DOOSAN **Document Transmittal** Upper Trishuli-1 HEP (216MW)	Date 2022-07-10	DT No.: UT1-HEP-DHI-PC-D-0042	SHEET 1 OF 1
DOOSAN NEPAL BRANCH OFFICE Address & Contact No. : Four Square Building, Naxal, Kathmandu, Nepal (P.O Box : 1387) + 977 1 692 3014	Project No. H20002	DOCUMENT DISPATCHED BY Courier Service ☐ Messenger ☐ Post-Air Freight ☐ Document System or E-mail ■ By hand ■	
DOCUMENT DISTRIBUTION ■ POWER CHINA (Subcontractor) ☐ Doosan's Site Office			
SUBJECT	Review Note RN-0157_Monitoring Layout Drawing of Underground Powerhouse and Transformer Cavern

REVIEW NOTE

Contractor	**Doosan Enerbility**		
Title of the Document	Monitoring Layout Drawing of Underground Powerhouse and Transformer Cavern		
Document No.	UT1-C-845-CVL-DG-70002	Revision	0B
Date of Documents	14.06.2022	Received Date	22.06.2022
Transmittal Form No.	UT1-HEP-DHI-D-0282		
Previous Review Date/Status	05.06.2022/RR	Prev. Review Note No.	RN-0134
Review Note No.	**RN-0157**	**Present Review Date**	**08.07.2022**
		Present Review Status	**AN**

Drawing No.: UT1-C-845-CVL-DG-70002 (sh. 1/5), version 0B

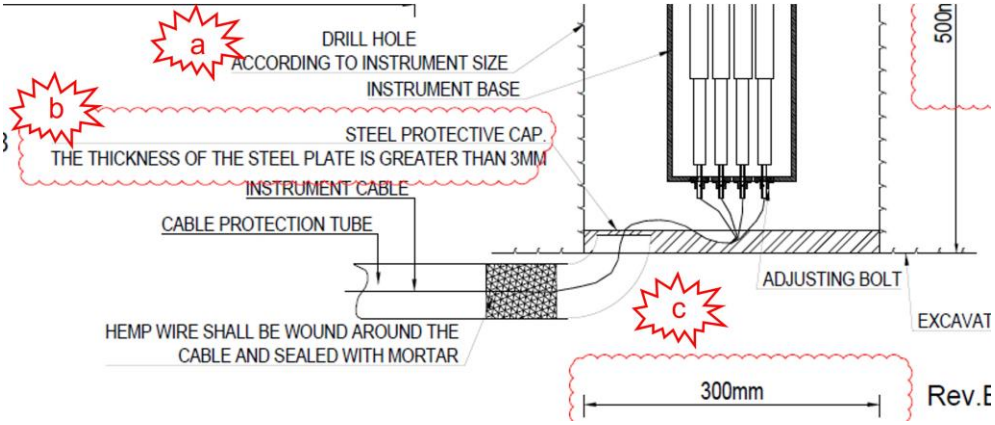
(a) Drill hole size for extensometer head as defined as 300 x 500 mm, but it is noted that drillhole is "according to instrument size. Type of instrument should be known. Therefore, drill hole size can be defined.

(b) The steel protective cap needs to have a thickness of 5 mm at least, better 8 mm.

(c) The protective cap must protrude at least by 100 mm over the borehole collar, and it must be fixed to the shotcrete liner with short rock anchors, which is already in place. All this must be detailed in the drawing.

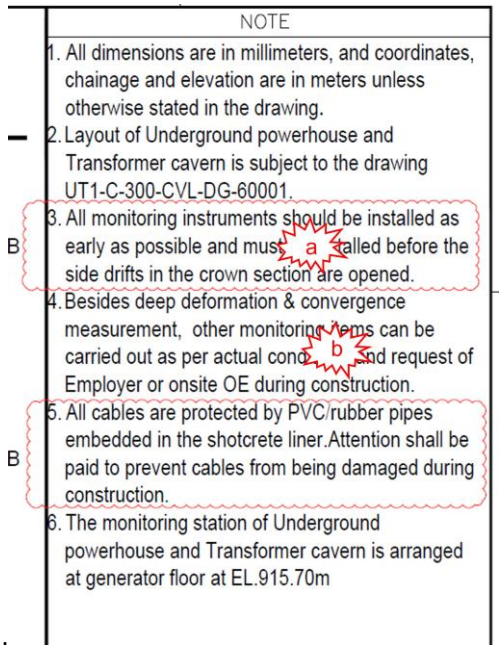
(a) Revise: „All monitoring devices, foreseen in the Central Crown Section, must be installed before opening of the Side Drifts".

(b) Replace "other monitoring items" with "additional instruments".

Drawing No.: UT1-C-845-CVL-DG-70002 (sh. 3/5), version 0B

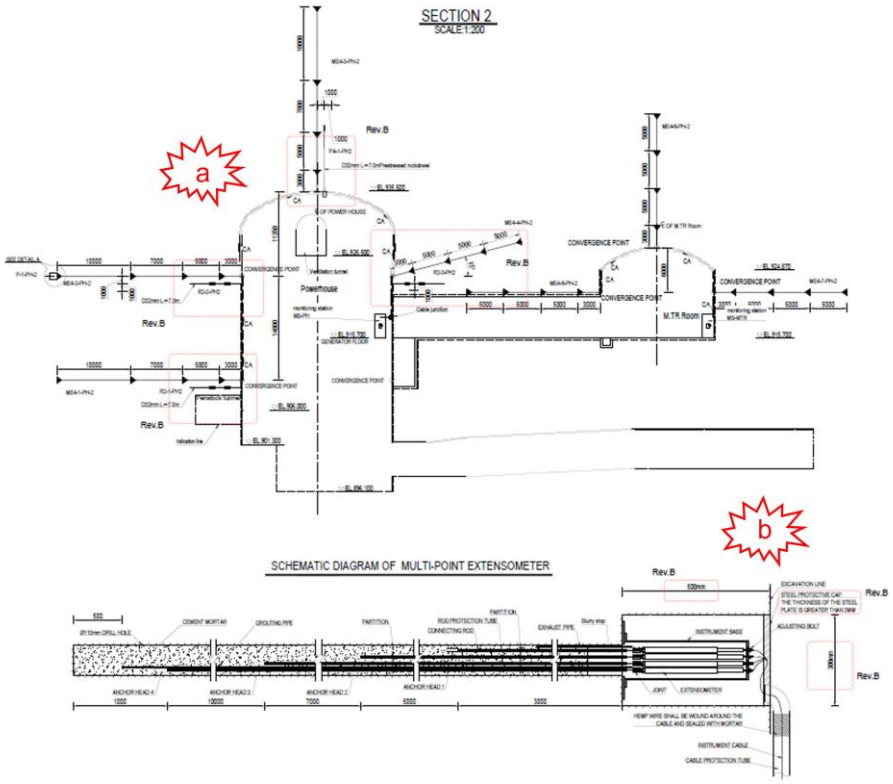
(a) Provide legend of instruments (also in the other drawings that show sections).

(b) Comments on extensometer apply as for drawing No.: UT1-C-845-CVL-DG-70002 (sh. 1/5), version 0B.

Drawing No.: UT1-C-845-CVL-DG-70002 (sh. 4/5), version 0B

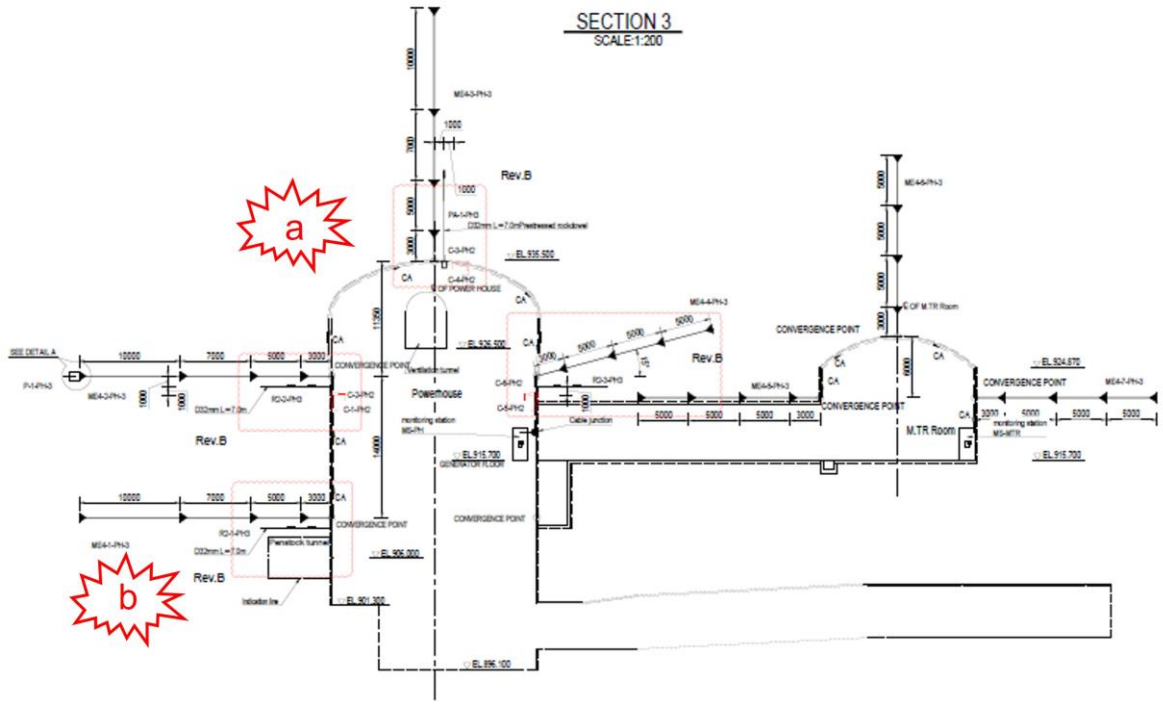
(a) Comments apply as for drawing No.: UT1-C-845-CVL-DG-70002 (sh. 3/5), version 0B, above.

(b) As (a).

Drawing No.: UT1-C-845-CVL-DG-70002 (sh. 5/5), version 0B

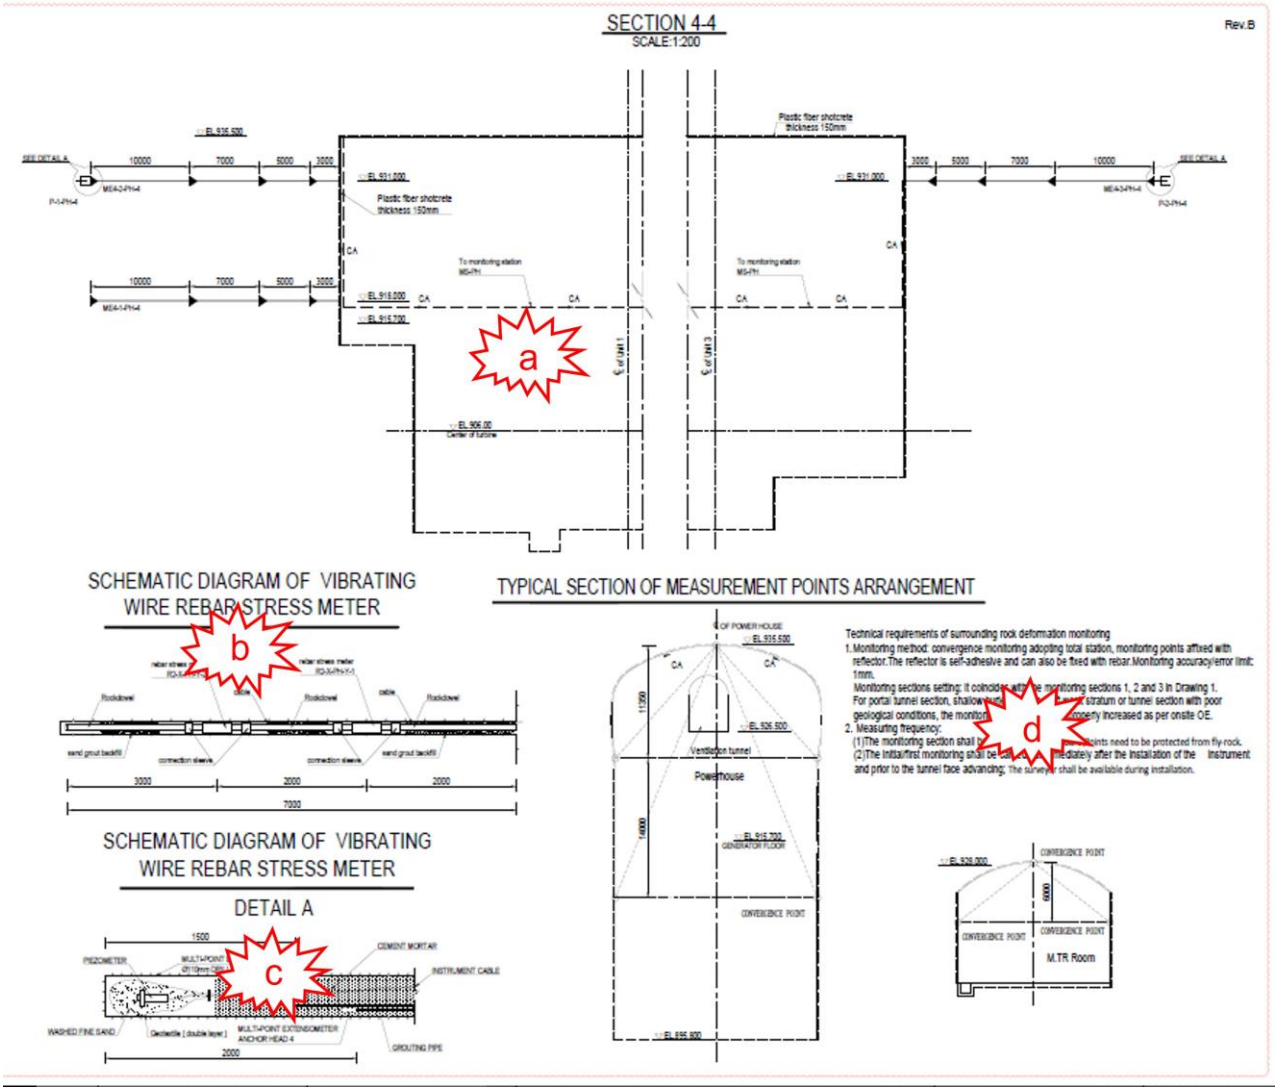
(a) Adjust the monitoring system as sketched further below.

(b) These instruments need also be installed on 5 m long dowels with one sensor, only. Provide respective sketch.

(c) Piezometers need to be installed in separately drilled holes, not in extensometer holes. Generally, such holes are percussion drilled and 10 m to 15 m long. Locations are selected at the site. Five pieces as listed in drawing No. UT1-C-845-CVL-DG-70002 (sh. 2/5), version 0B, are sufficient.

(d) See details referring to convergence measurements below. Adjust the notes to the Powerhouse and Transformer Hall. Currently it refers to a tunnel. Add a note that additional targets may be required and installed, elsewhere, if necessary. Revise.

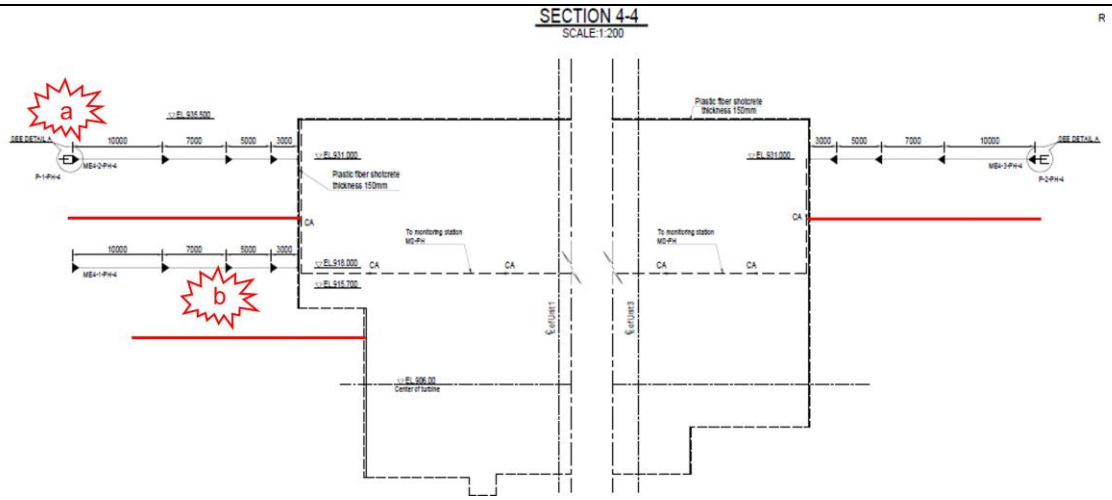
(a) Piezometers shall not be installed in extensometer boreholes. Revise.
(b) Rearrange location of extensometers as suggested (red lines).

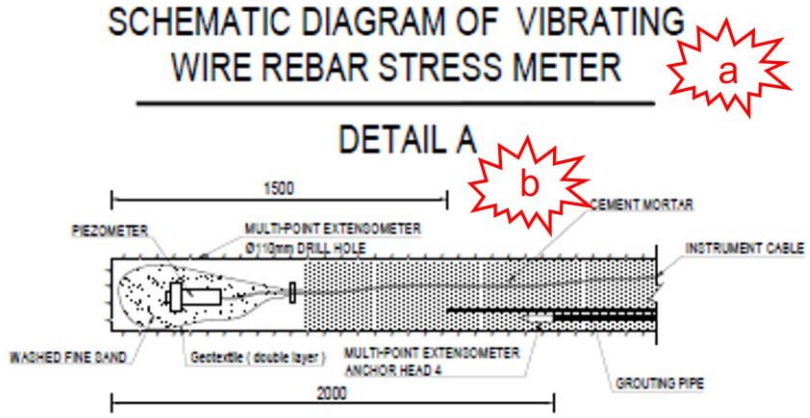
(a) „Details of Piezometer Installation“ and not Vibrating Wire Stress Meter”. Revise
(b) Revise drawing for a piezometer – not installed in an extensometer borehole.

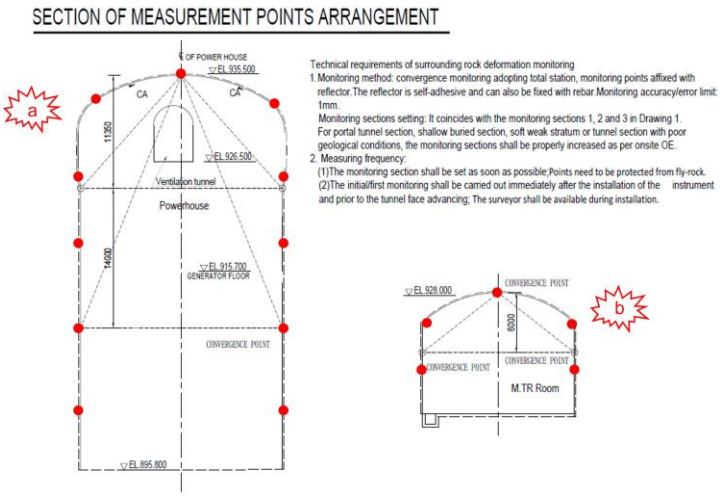
(a) Produce typical drawing for optical targets for convergence measurements. Here at the monitoring cross sections in the Powerhouse and in the Transformer Hall. Delete the dotted lines. Adjust, if necessary, targets to the location of extensometers.
(b) As (a).

SECTION OF MEASUREMENT POINTS

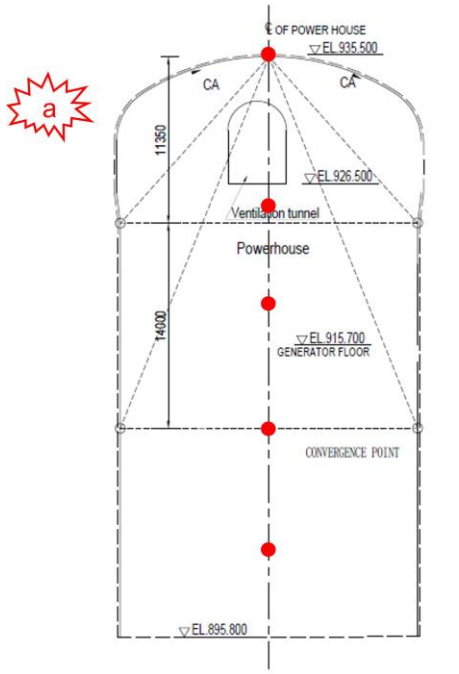
(a) Produce typical drawing for optical targets for convergence measurements for the end walls. Delete the dotted lines. Adjust, if necessary, targets to the location of extensometers.

Count all optical targets and include in list of drawing No. UT1-C-845-CVL-DG-70002 (sh. 2/5), version 0B.
